Brake Rotor Update to Reduce Noise

Classification Repair Bulletin **Section/Group** 33 - Brakes **Country/Region** All

Year All **Model** Model S **Version** All

This Service Bulletin supersedes SB-13-33-001 R1, dated 21-Oct-13. Each content change is marked by a vertical line in the left margin. Discard the previous version and replace it with this one.

Figure 1 (Machined front rotor)

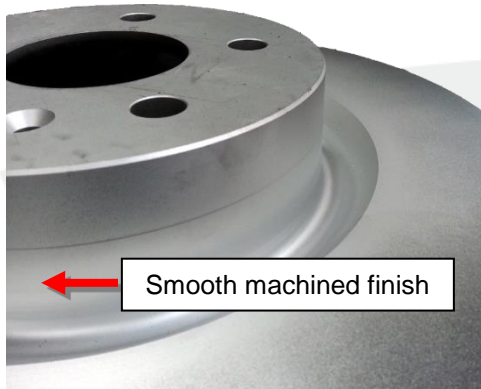
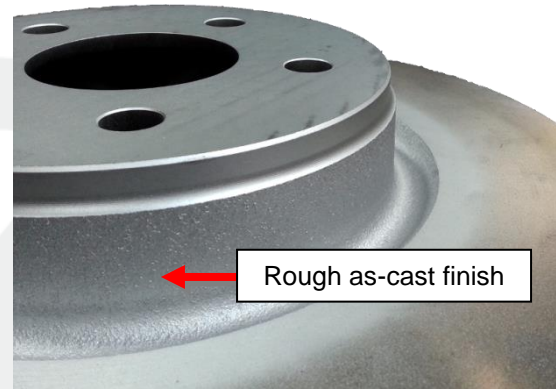
Some vehicles with 21 inch wheels exhibit a “moan” noise under light braking due to a vibration in the brake rotors. The noise is heard immediately before the vehicle comes to a complete stop. Brake performance is not adversely affected by this noise; however, customers might consider the “moan” annoying.

1. Check the design of the front rotors by looking through the openings in one of the front wheels. The standard front rotors have a smooth, machined finish on the hat (Figure 1). The service rotors have a rough, as-cast finish on the hat (Figure 2). Continue this procedure if the standard front rotors are installed.

Upon customer complaint, install updated service front rotors. Do not replace the brake pads unless they are near the minimum allowable thickness (2 mm).

4. Install 2 front rotors with as-cast outer hats.
5. Test drive the vehicle, making several light to moderate stops to check for proper brake operation. No special bed-in process is required unless the brake pads were replaced.
